RE: GEOTECHNICAL REVIEW OF MACRAES LOM DESIGN 2015

GEOTECHNICAL REVIEW
MACRAES LOM DESIGN 2015

PSM71-194R

OceanaGold Macraes Mine Geotechnical Review of LOM Design 2015 CORONATION PIT STAGES 2 TO 4 PIT PLAN	
PSM71-194R	Figure 7

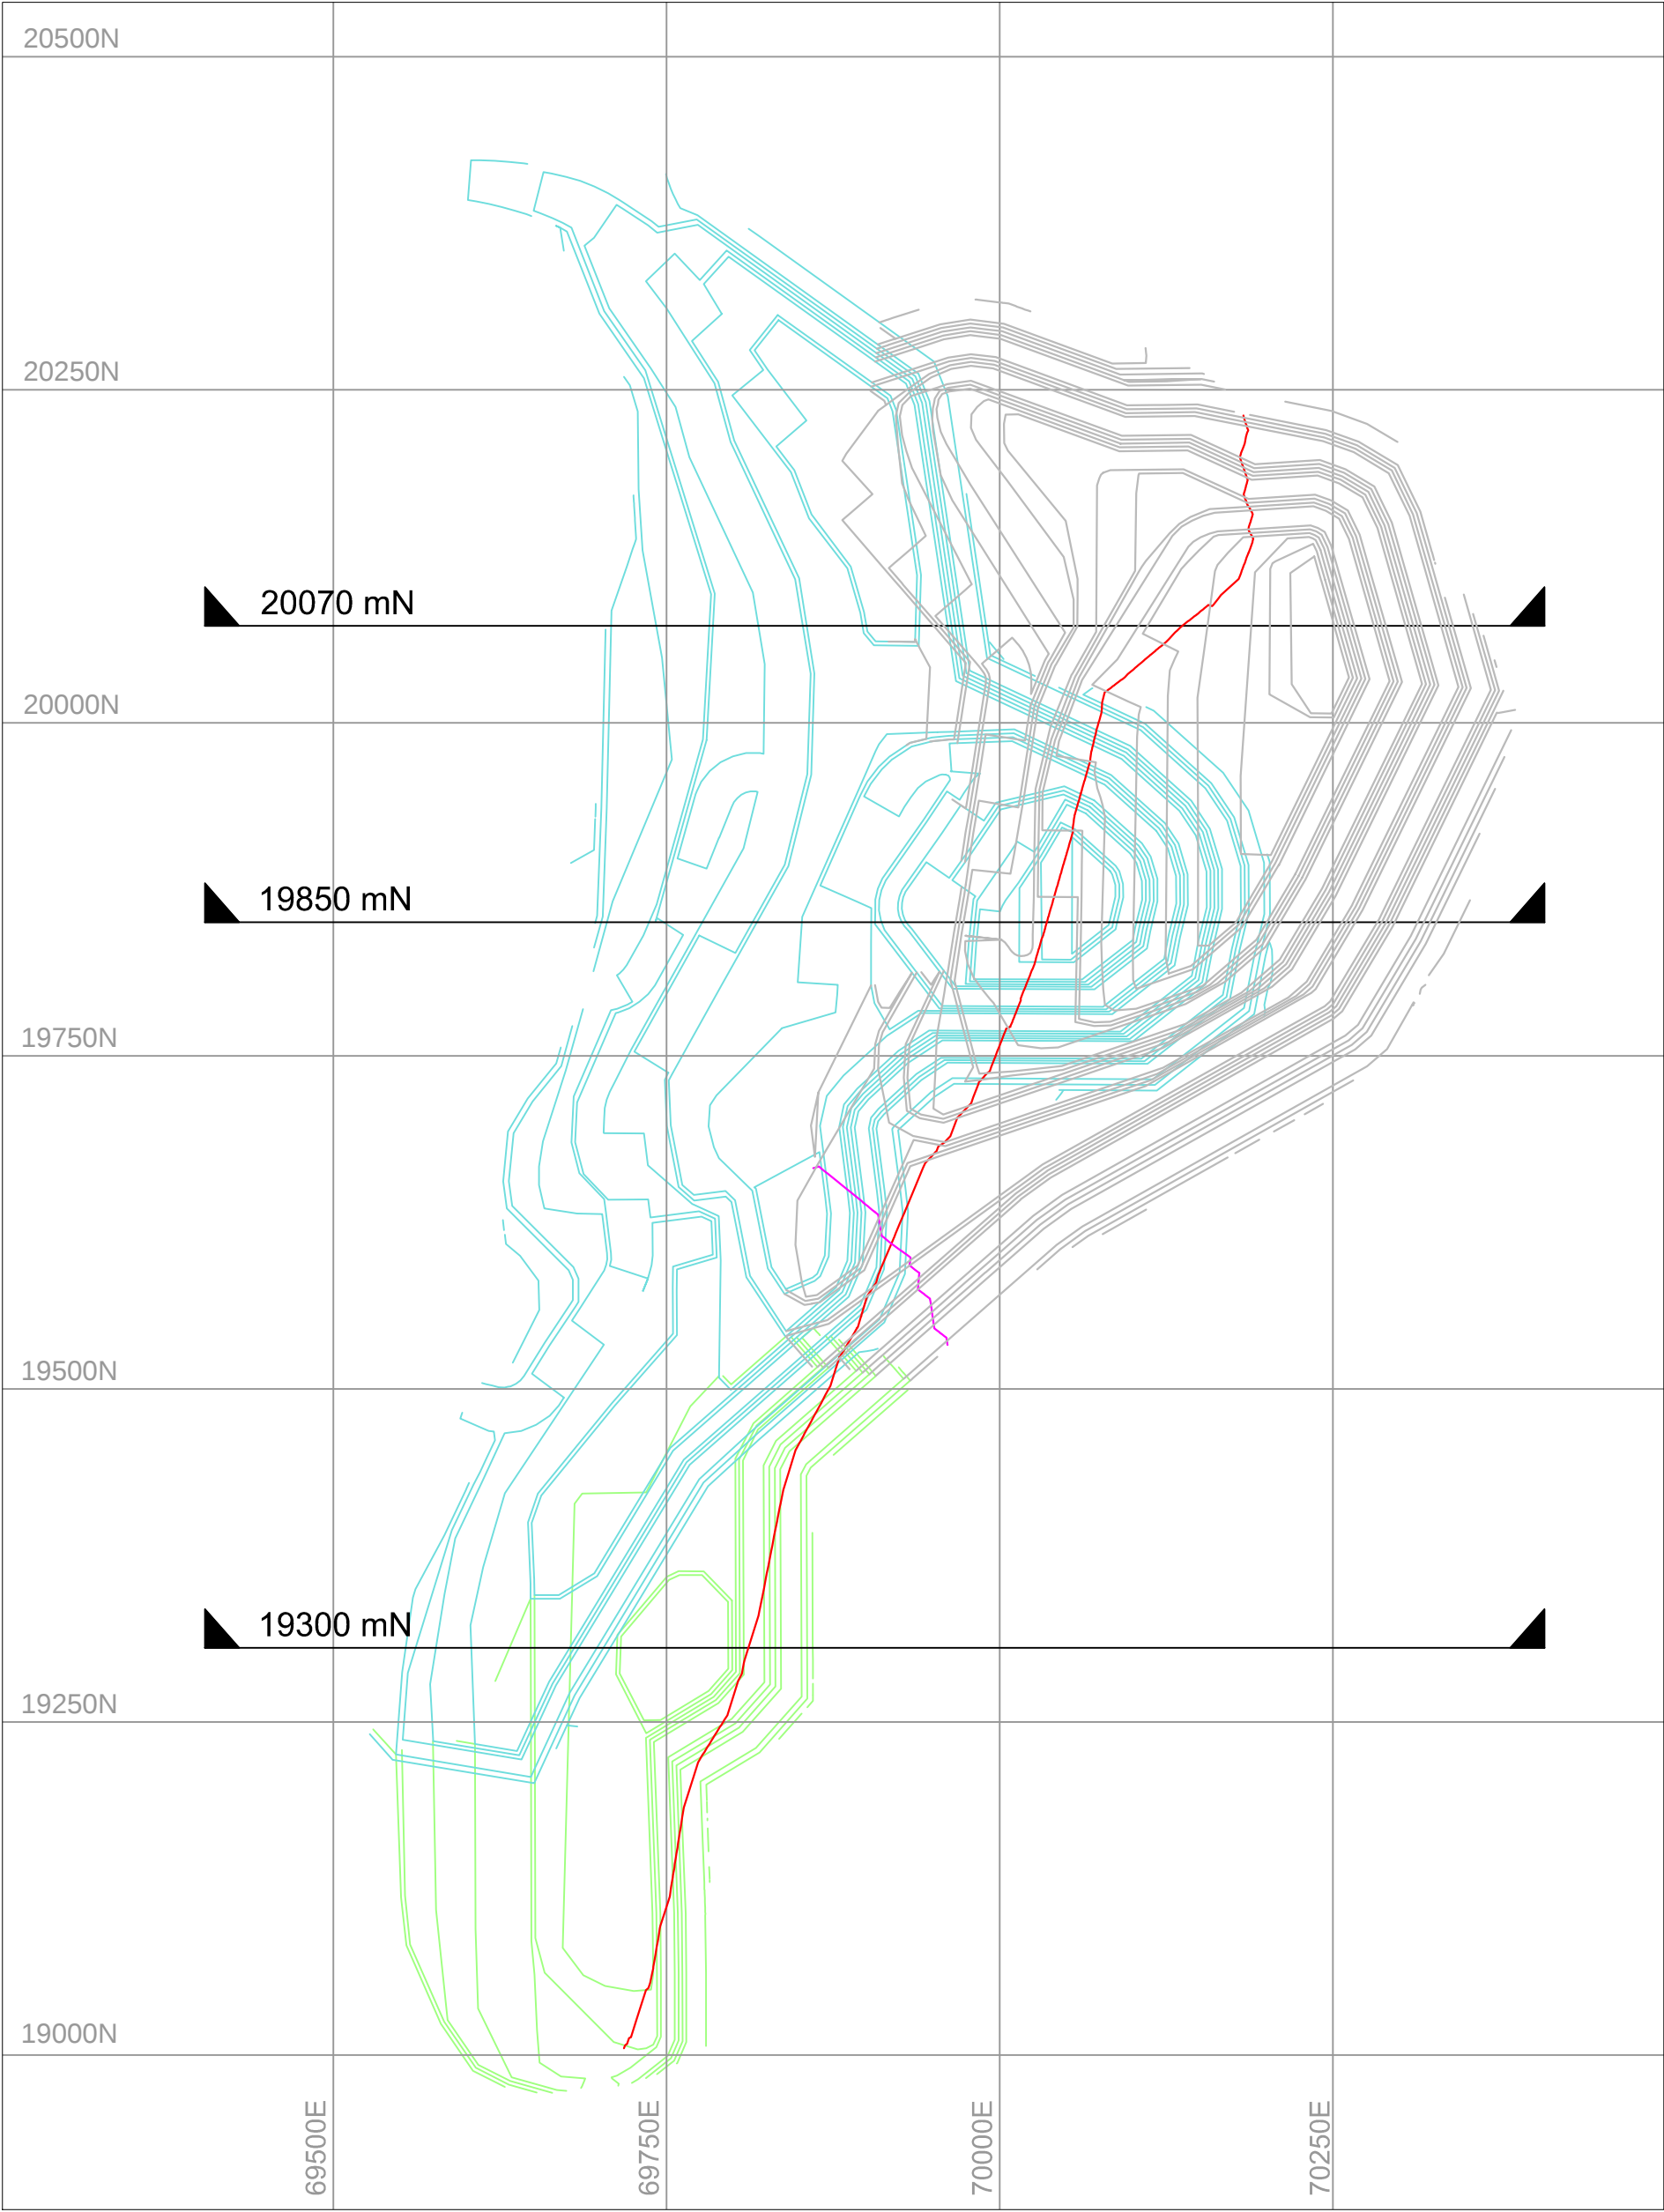
Figure 7 shows that Fault B may also influence the stability of east walls. This structure does however dip to the east and therefore into the wall.

- Fault B is generally located behind the eastern wall of Stage 2 however, the distance varies from daylighting to approximately 200 m
- Fault B strikes obliquely across the eastern wall of Stage 3. Localised bench scale failures can occur particularly if moderate west dipping fault and shear structures are also present.

Fault B poses a minor risk to the stability of the access road on the western wall of Stage 4. This fault strikes obliquely across the western wall, outcrops along the access road and its dip is also sympathetic to design batter angles. There is a risk of failure though as the slope angles are shallow, the risk is considered low.

Figure 9

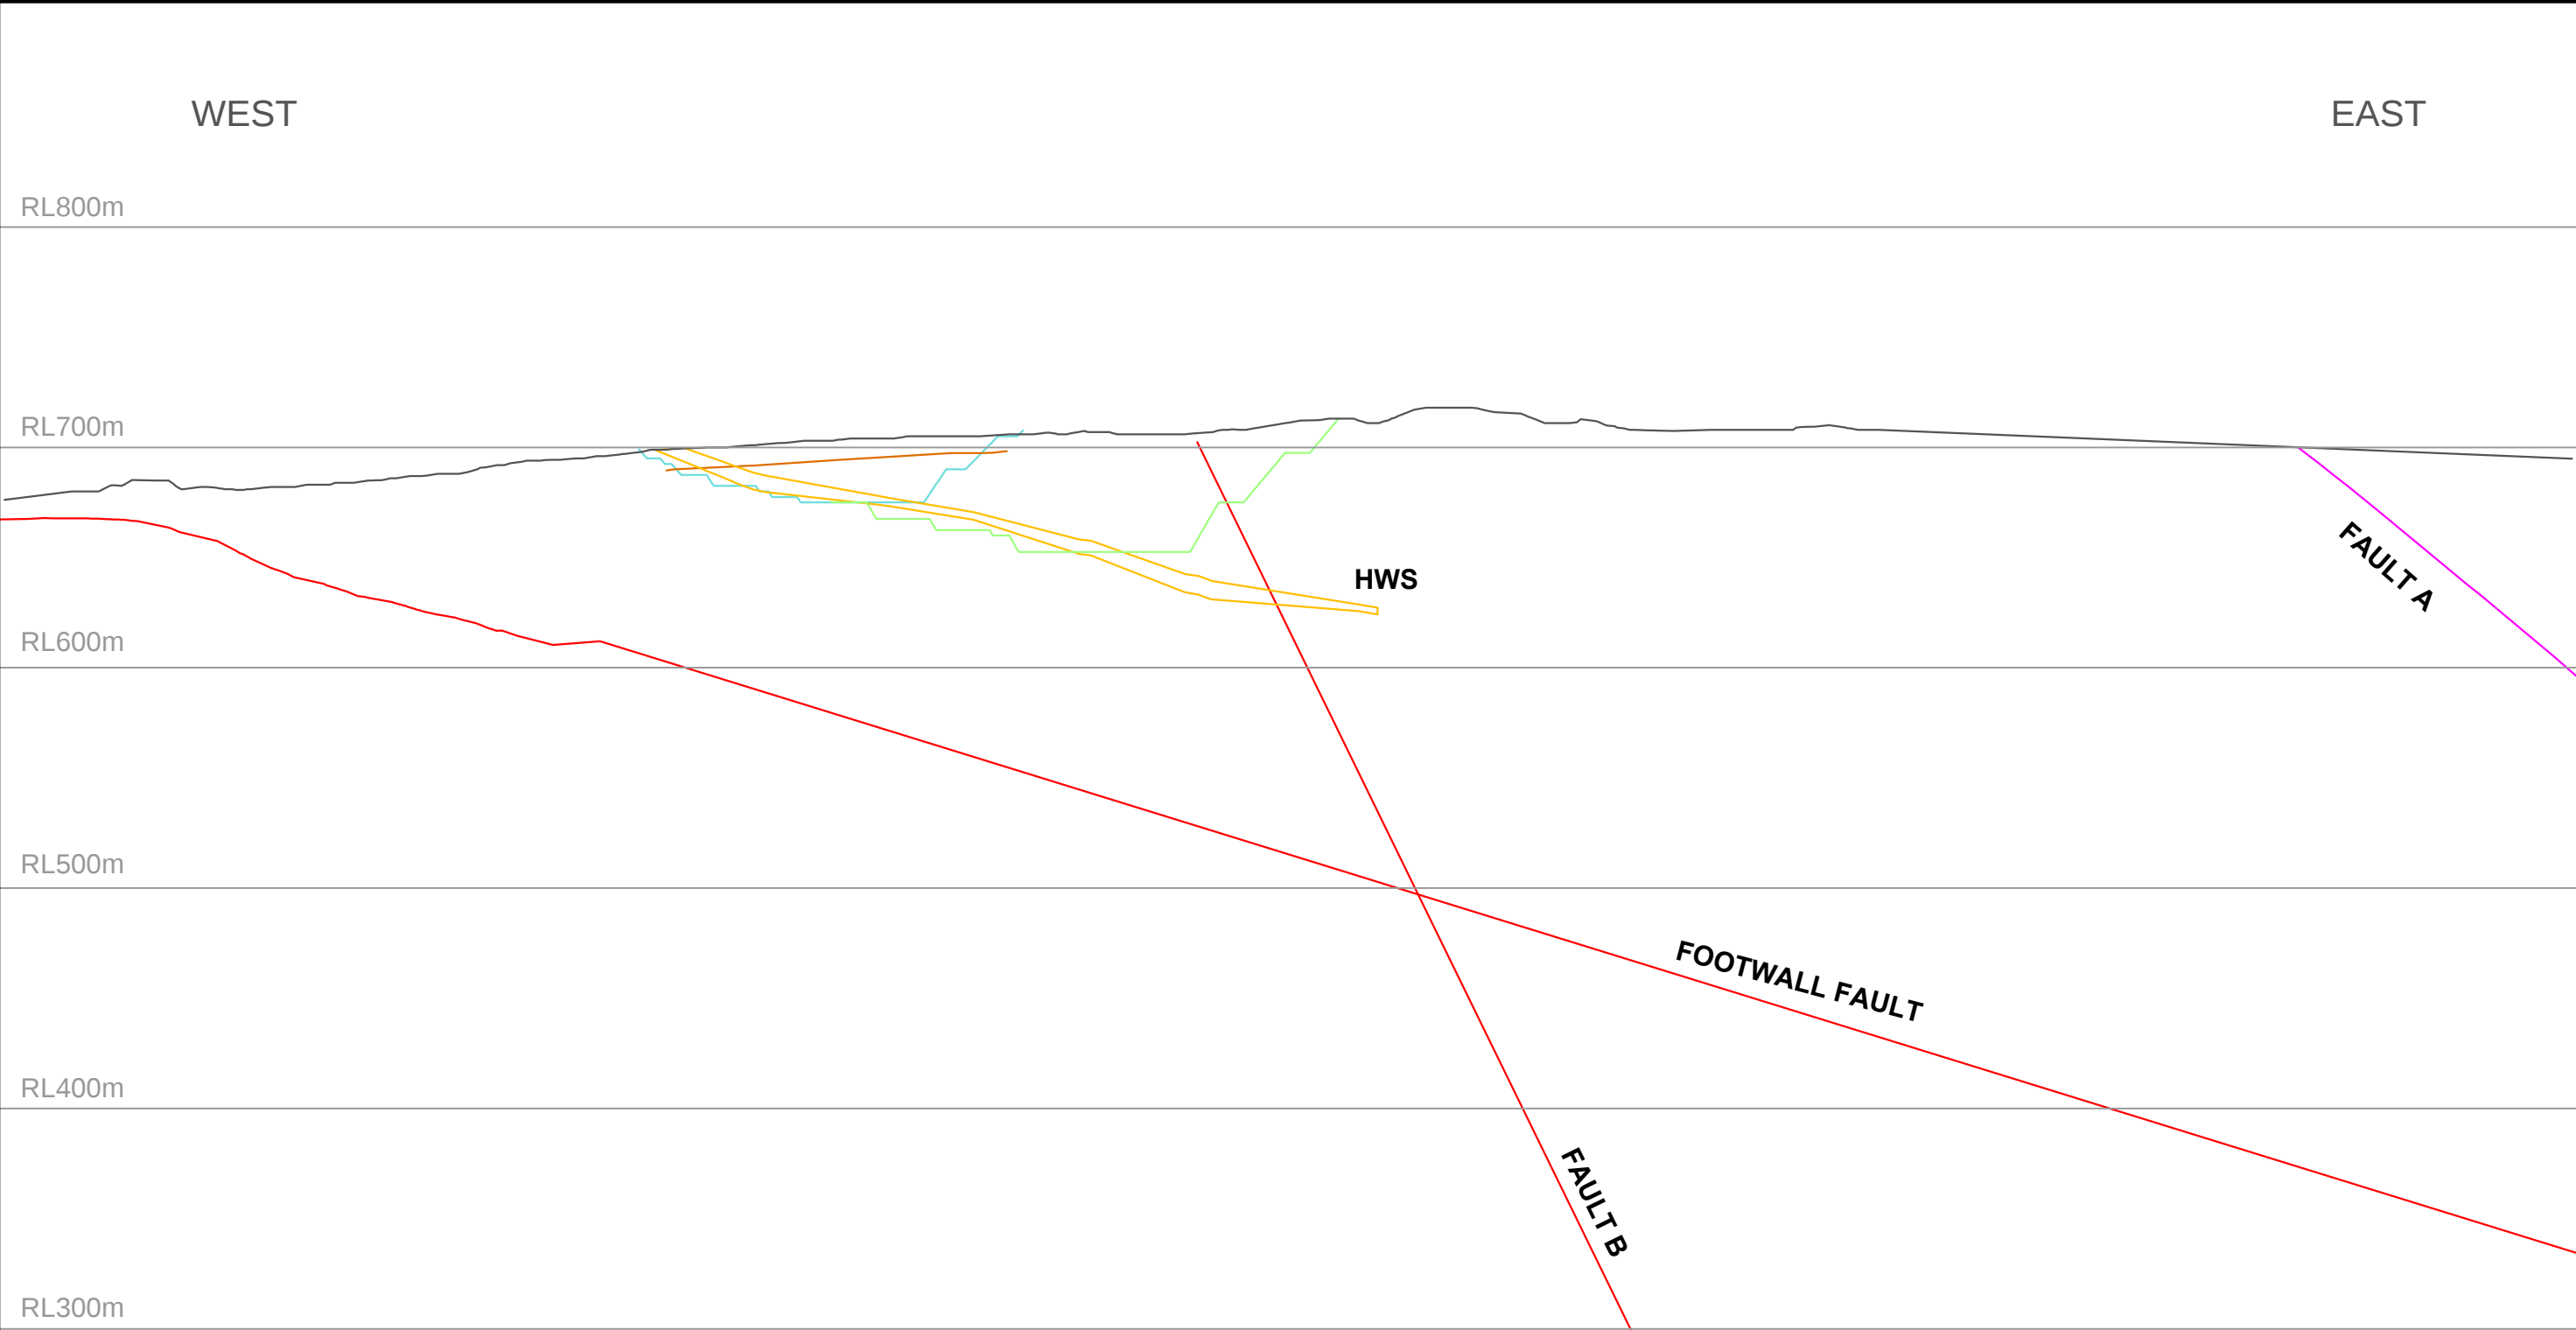
The west walls generally follow the Hanging Wall Shear (HWS) and are off-set at least 50 m from the Footwall Fault (FF) for each stage, refer to the sections in Figures 8 to 10. Past experience indicates that this off-set distance does not result in significant displacements along the FF. The FF is therefore not likely to pose a major risk to the stability of Coronation west walls.

OceanaGold Macraes Mine Geotechnical Review of LOM Design 2015 CORONATION PIT STAGE 2 HIGH RISK AREAS	
PSM71-194R	Figure 11

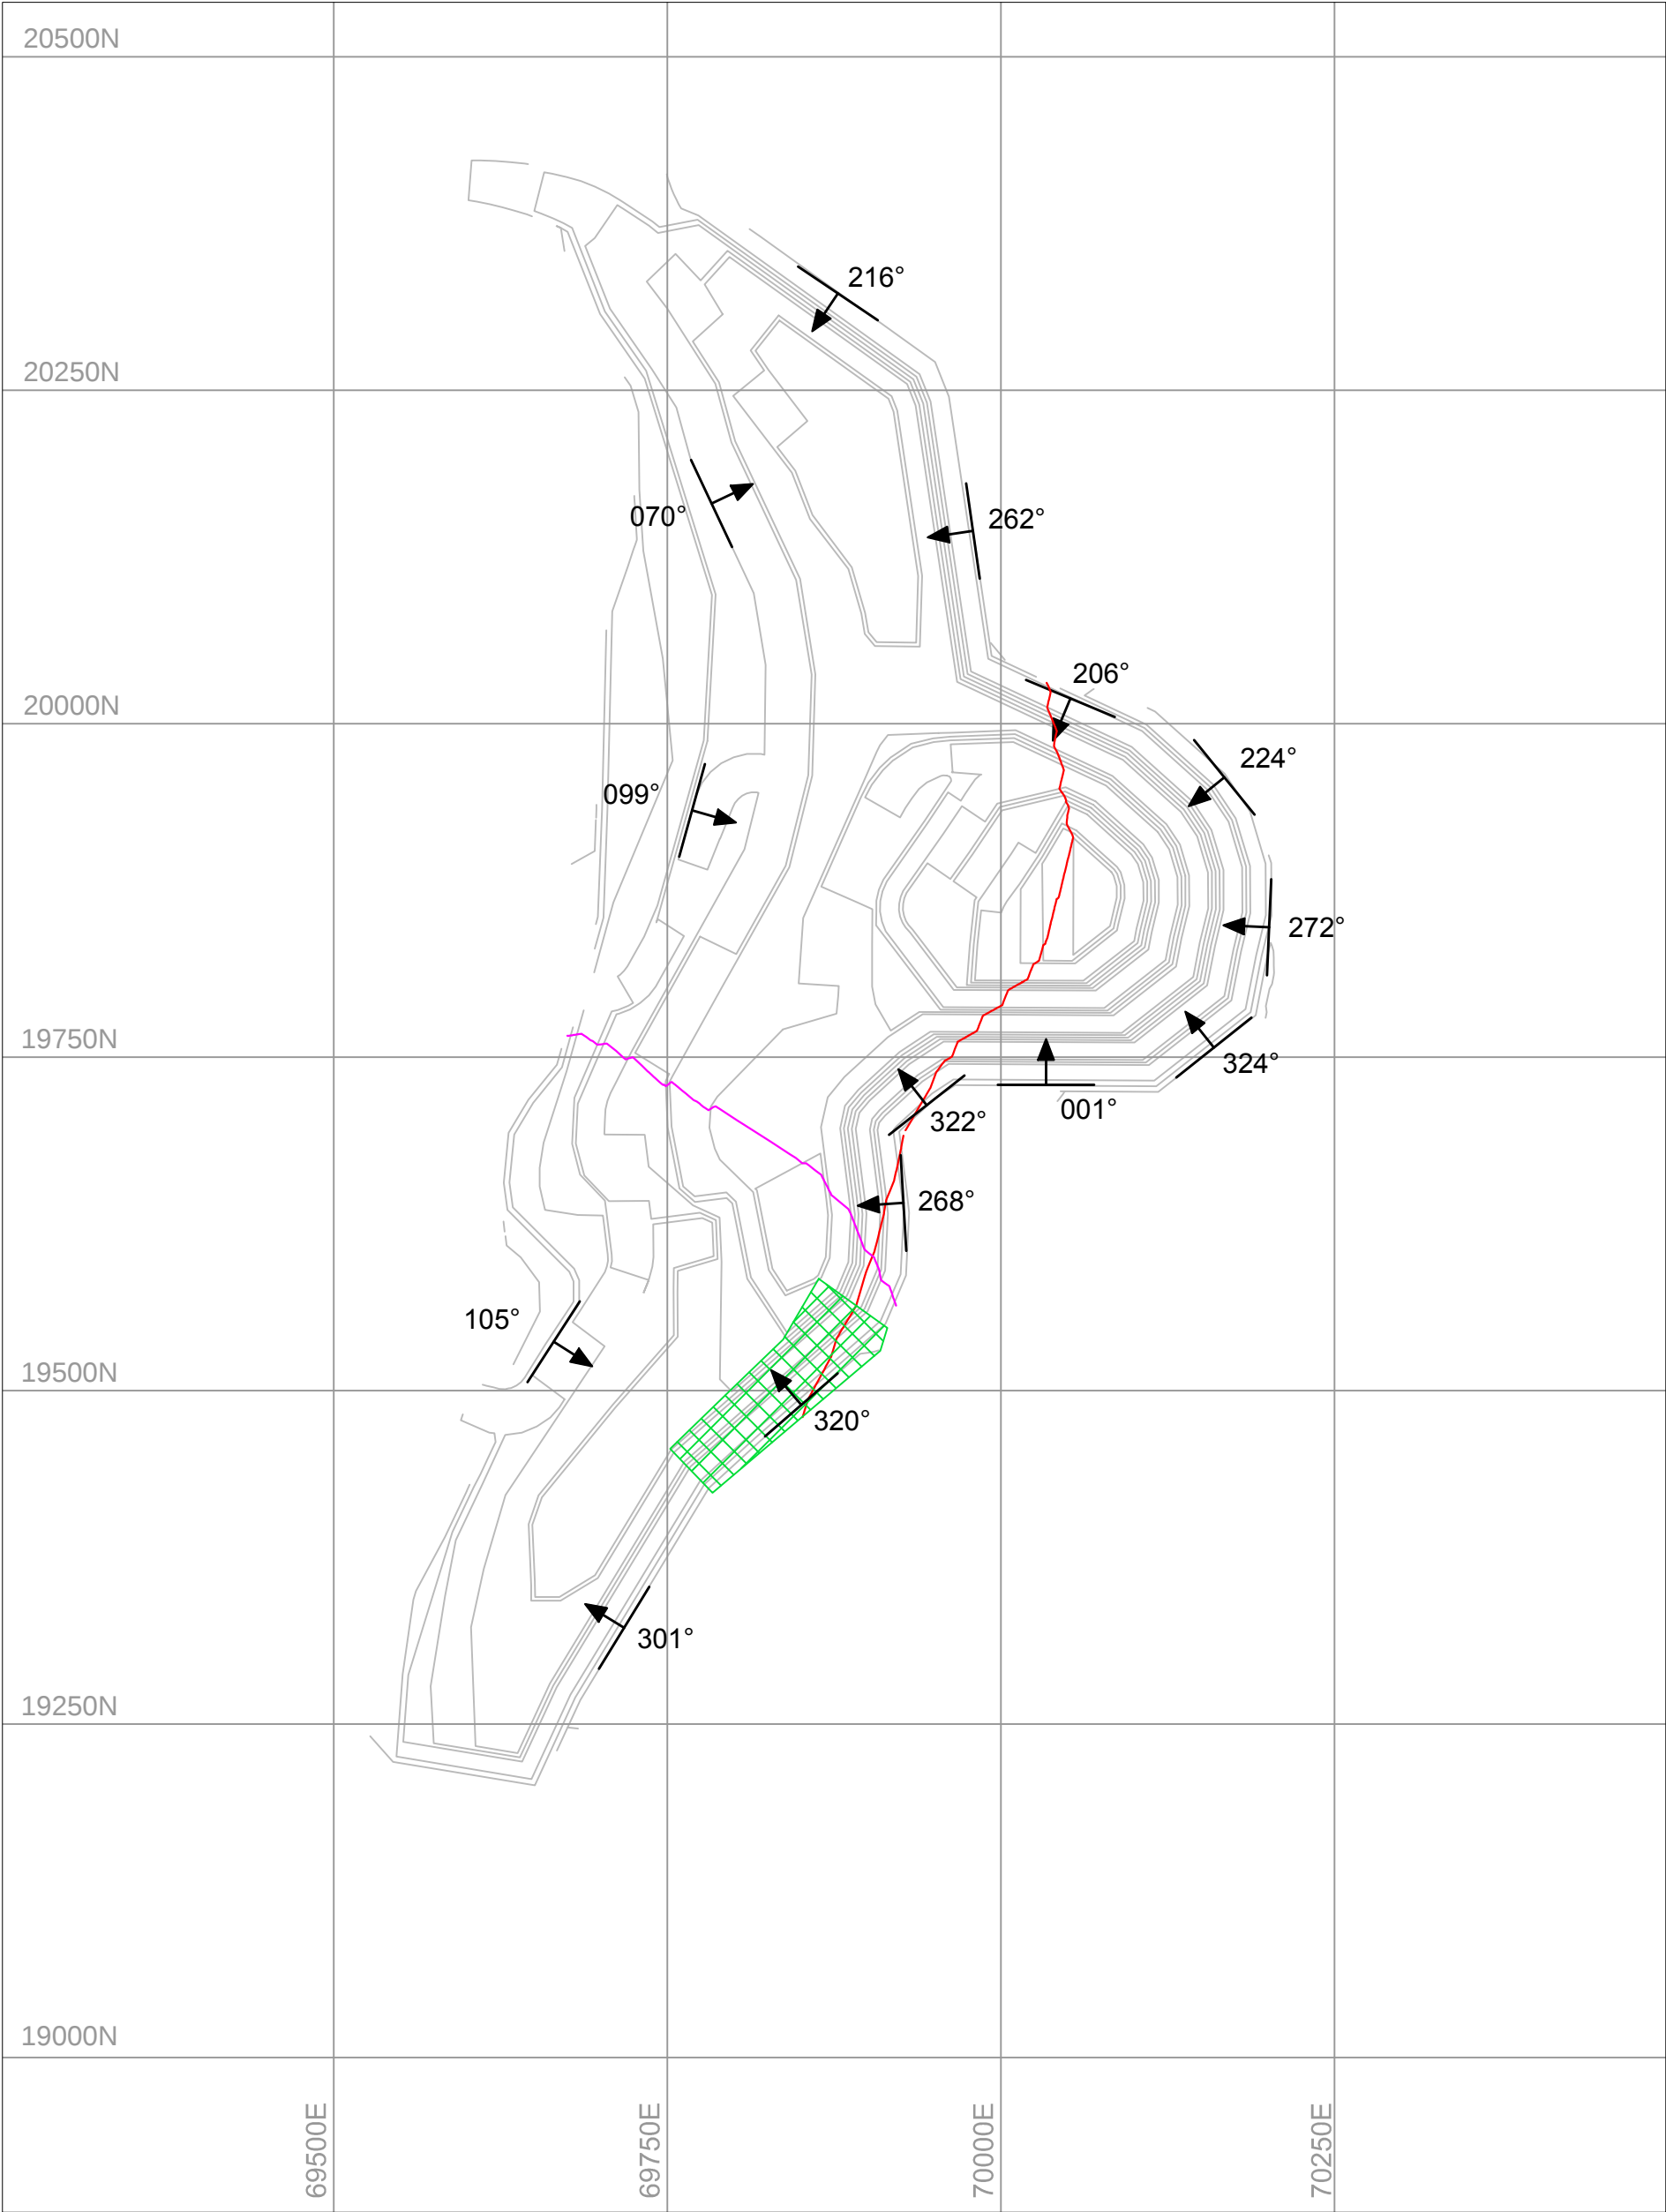
A number of unfavourably oriented slope sectors for Coronation east walls are included in Stages 2 and 3. These slope sectors are at risk of wedge and planar failure from north-south trending moderately west dipping fault and shear structures. They are identified in Appendix B and shown in Figures 11 to 12 as having a high risk of instability.

The impact of the north-south trending faults on the stability of the east wall is known by OceanaGold. It is understood that this risk is being managed by the day-to-day mining operations.

Geotechnical face mapping of east walls is recommended to facilitate the design of future cutbacks and pits.
